Item No.	Application No. and Parish	Statutory Target Date	Proposal, Location, Applicant
(1)	20/00674/FUL Stratfield Mortimer	11 May 2020 ¹	Change of use of land and the construction of a 150 space car park with alterations to the highway, landscaping, and associated works. Land to the South east of Mortimer Station, Station Road, Mortimer. Stratfield Mortimer Parish Council.
¹ Extension of time agreed with applicant until 7 August 2020.

Recommendation Summary: The Head of Development and Planning be authorised to refuse planning permission.

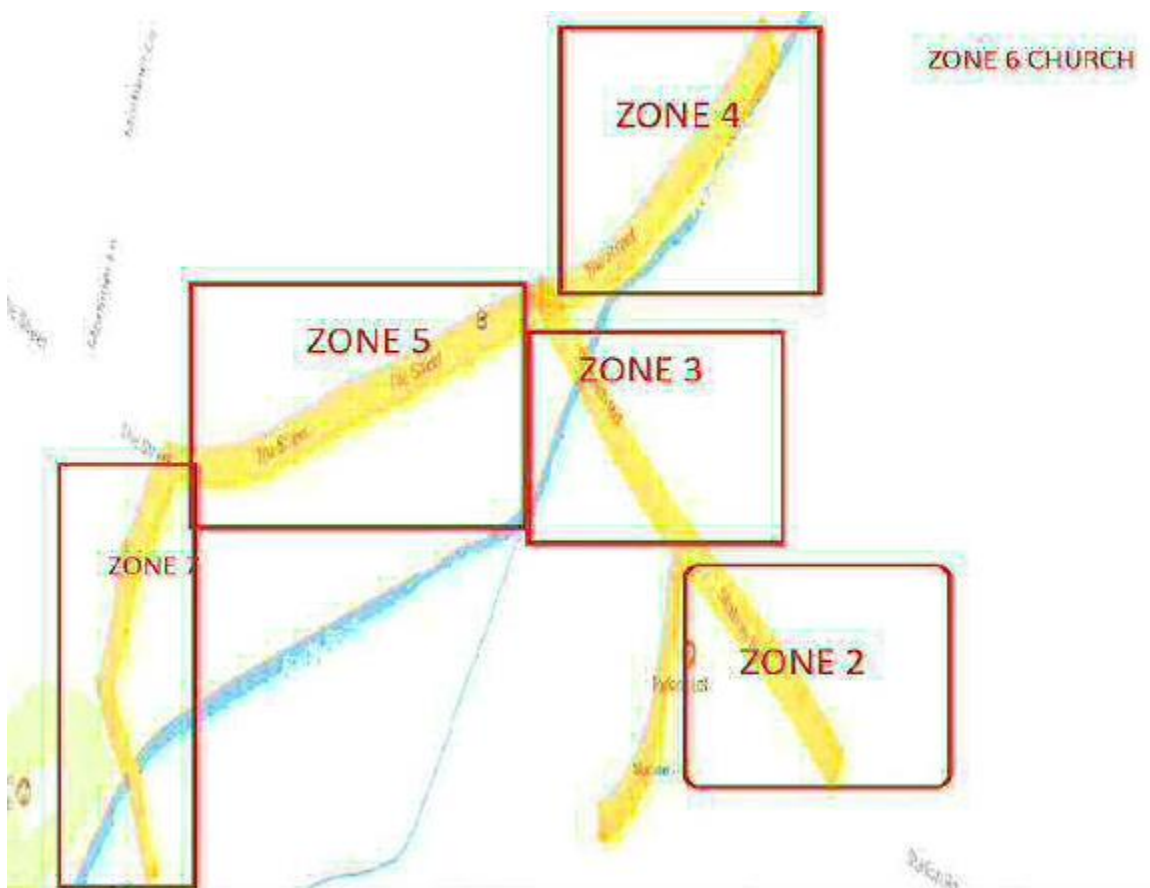
- 6.31 Overall the Council's landscape consultant assesses the site as part of an arable field forming part of a wider rural landscape contributing to the setting of Stratfield Mortimer and rural approach to it along Station Road. The proposed landscaping is not considered by them to contribute to mitigating the view of parked cars from the more sensitive locations of the southern side of Station Road bridge and the row of dwellings on the opposite side of Station Road. The band of tree planting to the southern side of the car park would provide a long term landscape feature of value but is not considered by them to compensate for the size, scale and urban character of the car park. Planting adjacent

to Station Road on the southern side of the bridge they are also concerned would be to the top of a slope that will be dry and not grow well, whilst planting at a lower level under the existing tree would not provide long term screening.

- 6.32 The applicant's landscape consultant reiterates that the proposal includes 0.4ha of woodland and other planting including 0.5km of native hedge planting and that in their opinion it would significantly (if not fully) mitigate the adverse landscape effects. However, it's not clear if this only refers to the planting shown within the red line. Any shown outside of the red line cannot be taken into account as it cannot be conditioned to be provided. Extract of landscape strategy plan below:

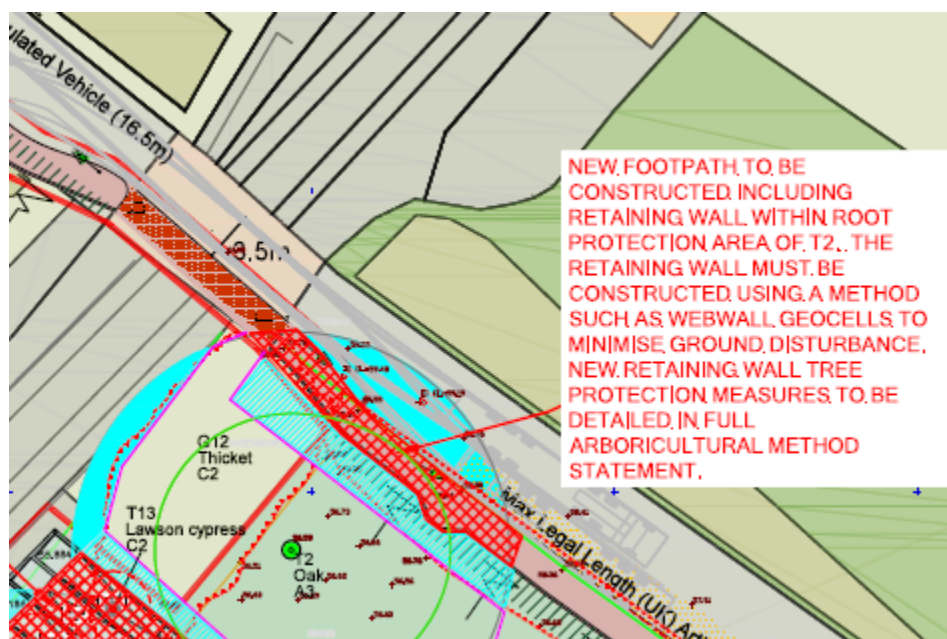
- 6.45 The arboricultural impact assessment notes the difference in ground levels is approximately 1.4m between the field and station platform. The footpath to link towards the bridge on Station Road will require construction of a retaining wall for structural support although details have not been prepared the change in ground level 2.2 and 2.8m high. Please see extract from plans:

- 6.47 The Council's Tree Officer notes that the group of semi-mature planted trees and hedgerow to the northwest of the red line where the new footway in the extract from the plans above is proposed to connect to the existing car park were not considered. Some loss of the trees is expected here and further clarification on these impacts has been requested. The arboricultural impact assessment states that the new footpath will run through an area of trees to the west side of the road bridge and that the trees in this area have not been surveyed. As there are considered to be other issues that cannot be overcome the additional clarification has not been sought or provided on this.
